# CITY OF ALBUQUERQUE

**Re: Touro College of Dental Medicine/ Tenant Improvements**  
**2425 Ridgecrest Dr. SE**  
**Traffic Circulation Layout**  
Architect's Stamp 04-10-24 (M18-D006)

Based upon the information provided in your submittal received 04-15-24, the above referenced plan cannot be approved for Building Permit until the following comments are addressed:

# TCL-101

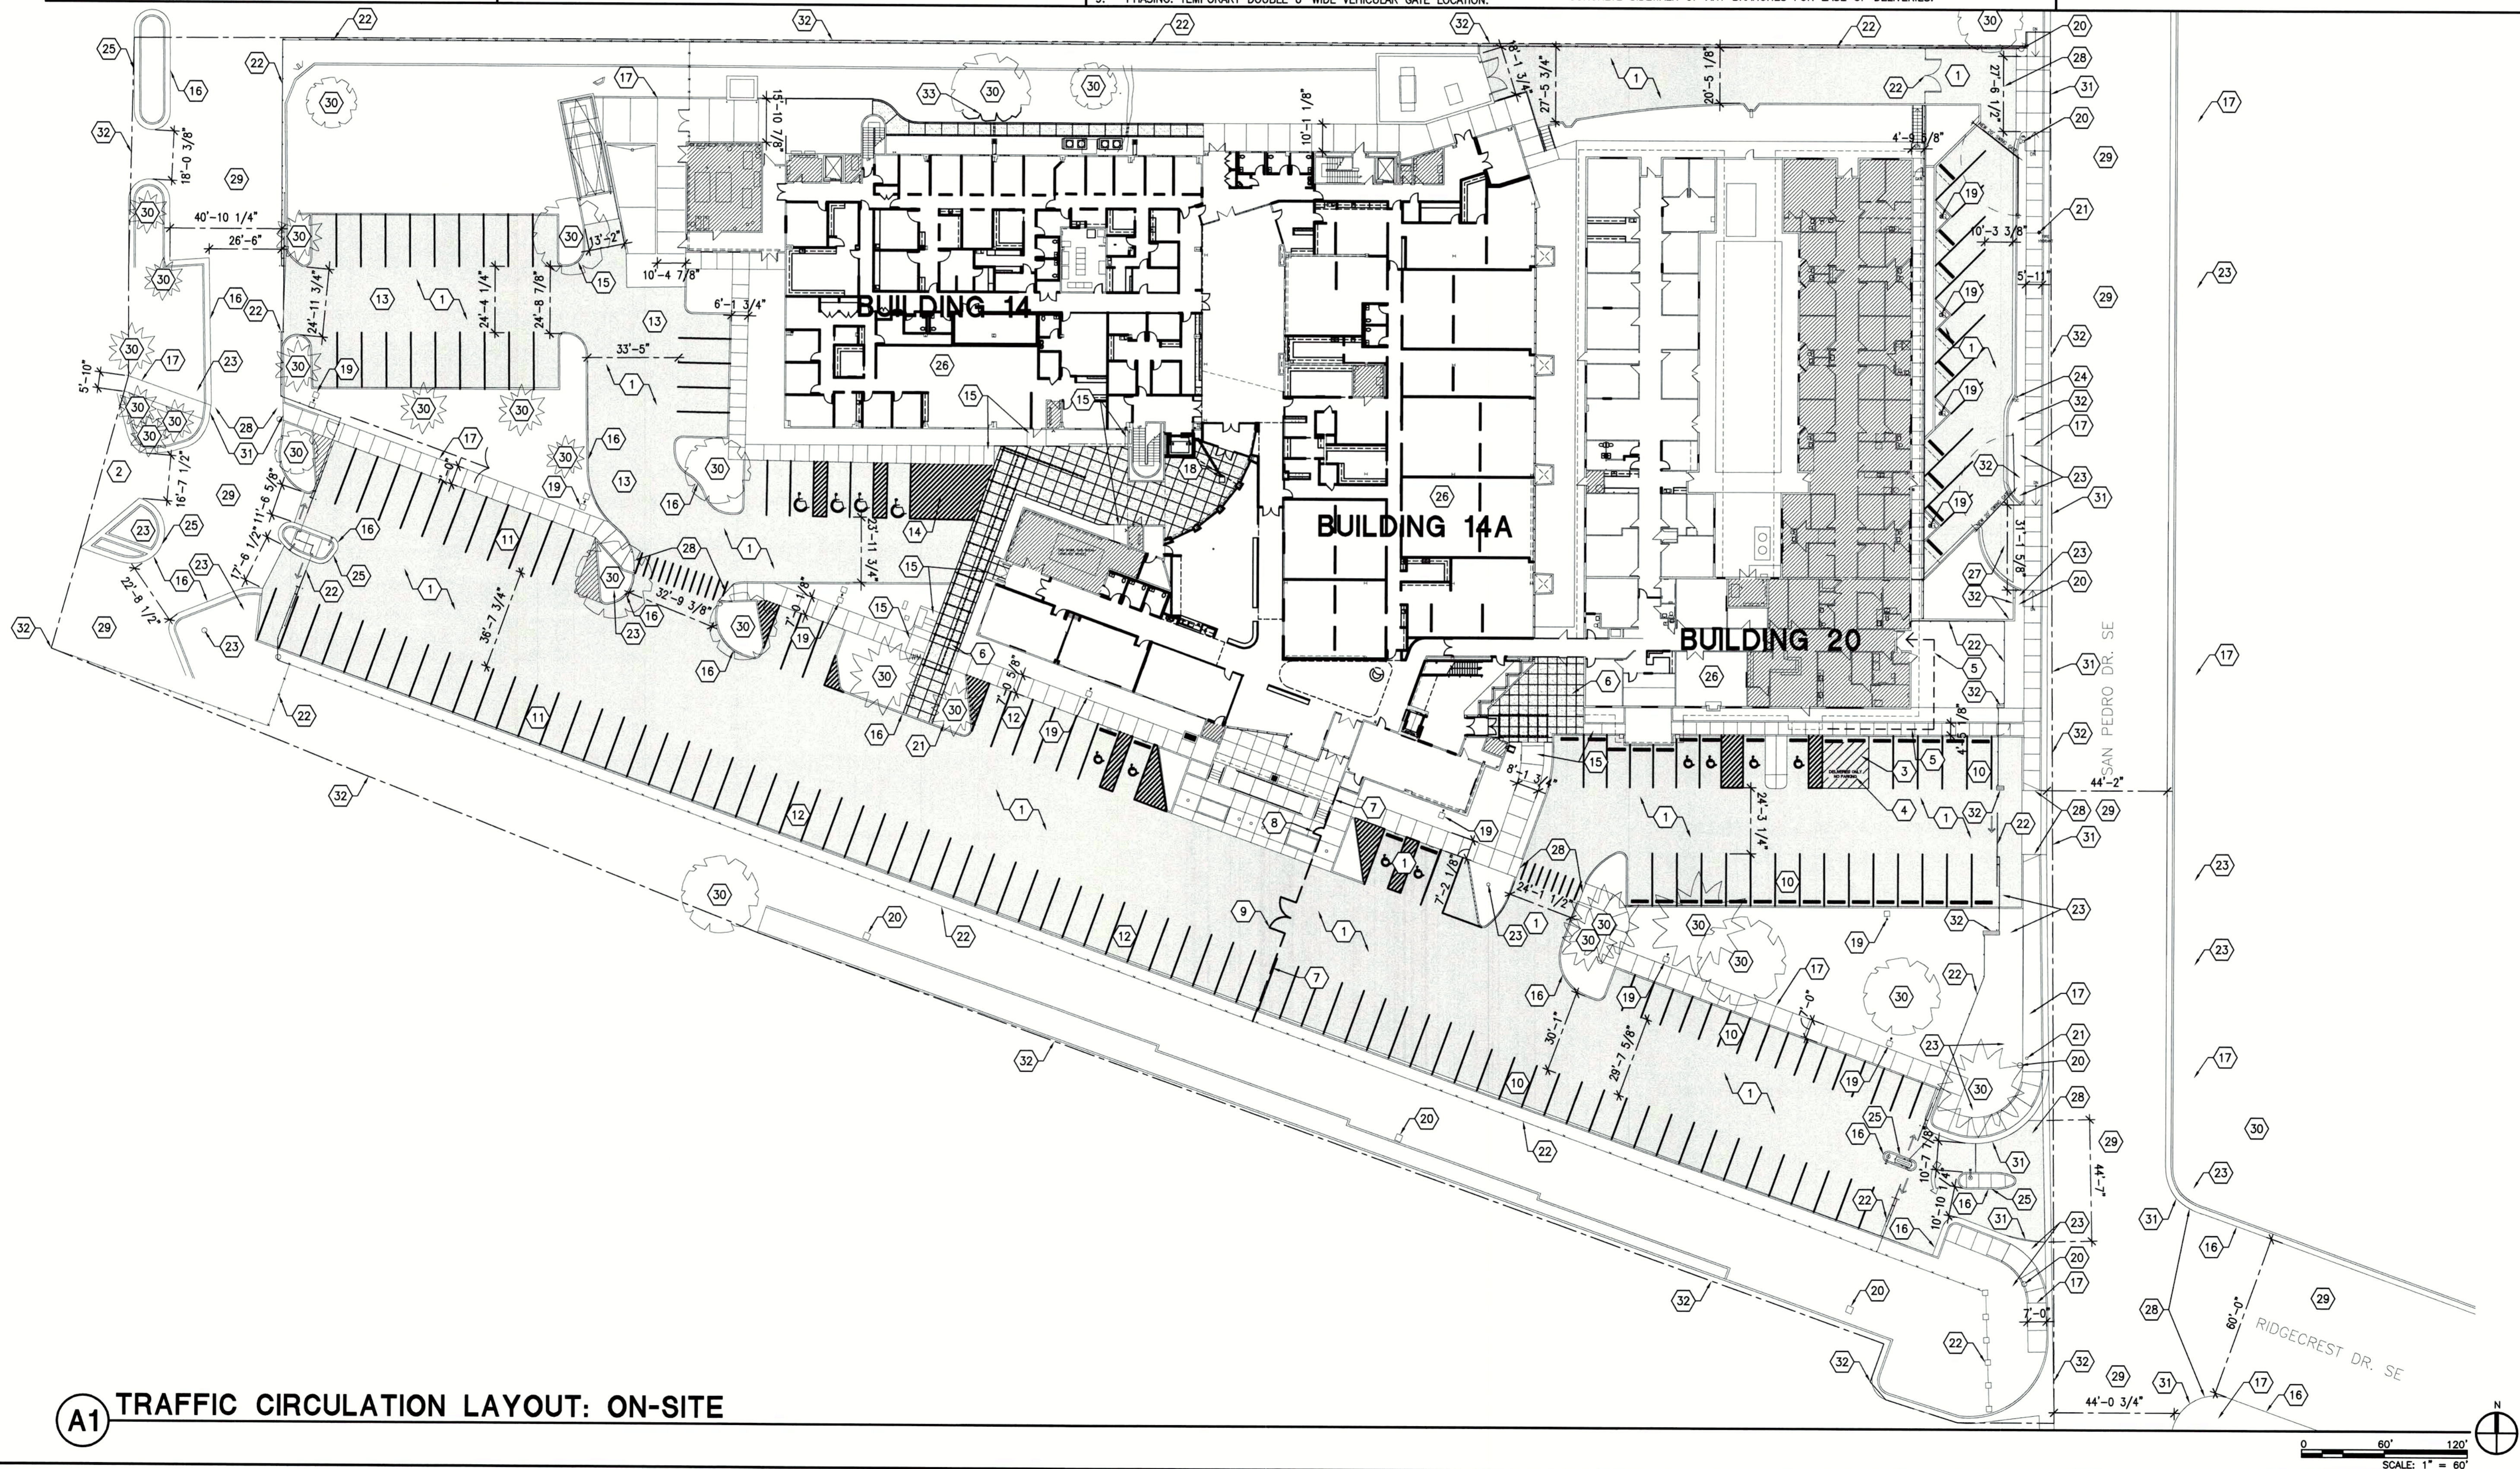
25. Please specify the City Standard Drawing Number when applicable.
26. Key note 17 in sheet TCL-101 and keynote 2 in sheet TCL-102: Add a note stating "All broken or cracked sidewalk must be replaced with sidewalk and curb & gutter." A build note must be provided referring to the appropriate City Standard drawing.
